TOWN OF SOUTH WINDSOR PLANNING & ZONING COMMISSION APPLICTION 21-36P, 25 TALBOT LANE SITE PLAN

NOVEMBER 9, 2021

Questions / Comments towards Traffic Impact Study (October 2021 version) and other matters for Proposed Warehouse Development

25 Talbot Lane South Windsor, Connecticut

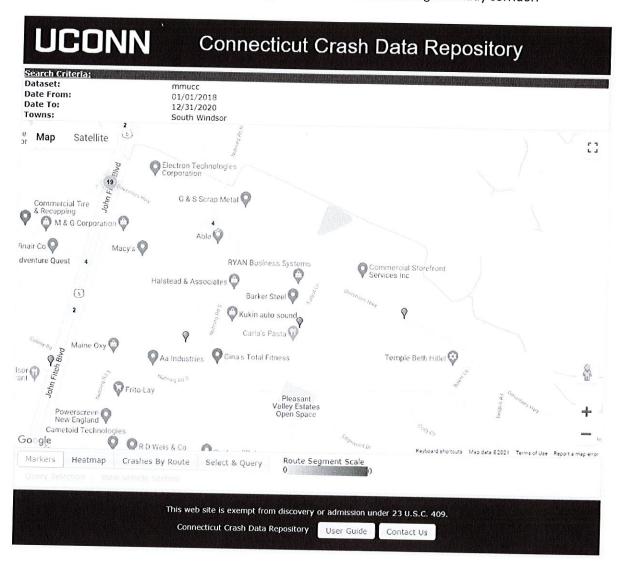
3. The crash analysis states only one crash occurred during a three-year period from January 2018 to December 2020. Has ConnDOT reviewed and approved this crash analysis?

The consultant should please review this analysis for the set timeframe as the <u>UConn</u> <u>Connecticut Crash Data Repository</u> notes several crashes that occurred along Governors Highway within the limits of the study area; five crashes occurred along the Governors Highway with one additional crash along Talbot Lane. Please see the screenshot below that captures these crashes from the UConn Connecticut Crash Data Repository.

1: John Fitch Blvd./US-5 & Governor's Hwy. Lanes, Volumes, Timings

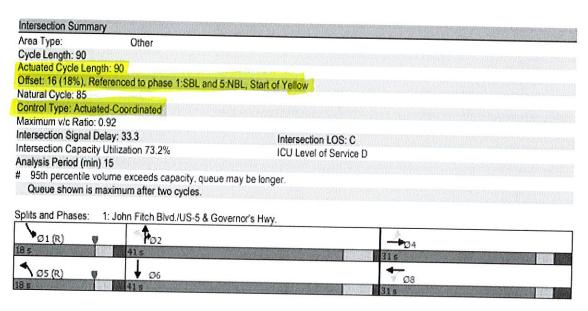
For the intersection node #1, John Fitch Boulevard (Route 5) and Governors Highway, the northbound and southbound operations show conflicting phasing. The northbound left-turn has a permissive-protected phasing (pm+pt) and southbound left-turn has protected (prot) phasing. Based on the existing conditions at this signal, protected phasing should be applied for phase 1 and phase 5 operations (see screenshot turn types highlighted below from Synchro Report).

Additionally, this intersection notes that actuated-coordinated control is provided at the intersection node #1, John Fitch Boulevard (Route 5) and Governors Highway. Can the consult/traffic engineer please share why this control type was used as there are no traffic signals within 1000-ft of the intersection. Coordination is typically provided to facilitate smooth flow between signalized intersection in order to increase operations for the mainline through movements (typically the busiest traffic movement); therefore, the offset would be placed on phases 2 and 4. It is interesting that a traffic signal offset would be placed on the mainline left-turns (phases 1 and 5) for this intersection (see screenshot turn types highlighted below from Synchro Report).

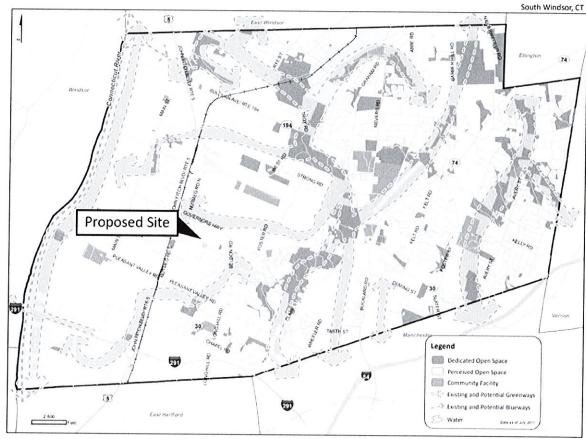
9. Is there a reason why intersection spacing was not evaluated for the site plan or traffic analysis?

Section 11-1.05 Intersection Spacing within the <u>Revised 2013 ConnDOT Highway Design Manual</u> states all new intersection should be spaced at least 400-ft apart in order to avoid short gaps between opposing T-intersections.
